From: Sharna Holland
Sent: Friday, 20 October 2023 6:11 PM
To: Darren Wooding
Cc: Tracey Gillett; Amanda Moylan; Matt Wilson
Subject: 271 Bernhardt Street, East Albury

I refer to Development Application 10.2023.40347.1 for 'Group Home – Seven (7) Residences, Retaining Walls, Car Parking, Front Fence, Vegetation Removal & Demolition' at 271 Bernhardt Street, East Albury.

Response to RFI-Albury Development

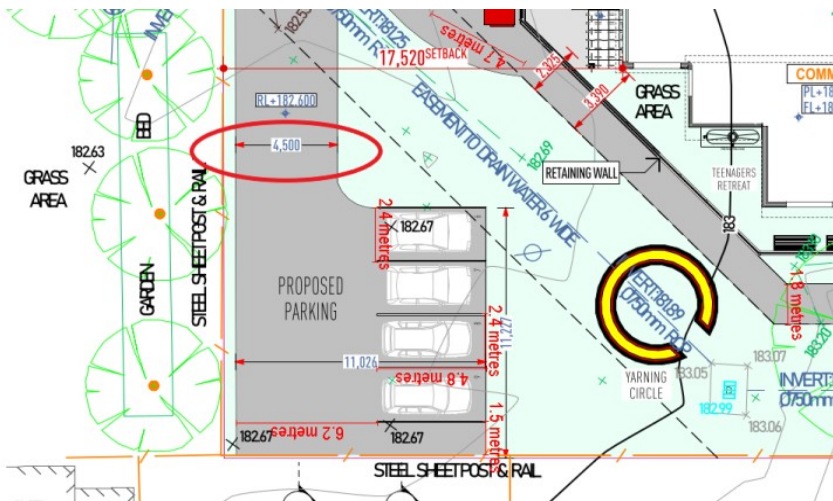
- The 4.5m roadway width to the carparking spaces in the south-west portion of the site (see image below), will not accommodate two-way vehicle access. Please increase the width of the roadway to a minimum of 5.8m.

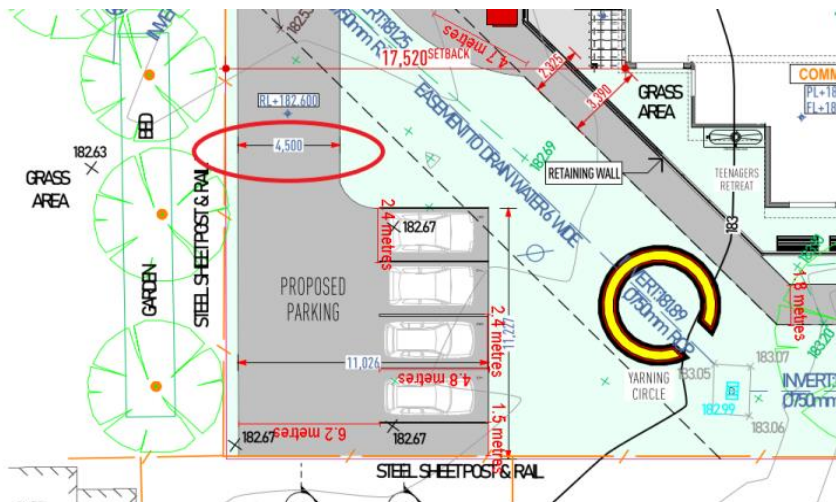
- o Cindy
- The 4.5m roadway width to the carparking spaces in the south-west portion of the site (see image below), will not accommodate two-way vehicle access. Please increase the width of the roadway to a minimum of 5.8m.

- o Cindy
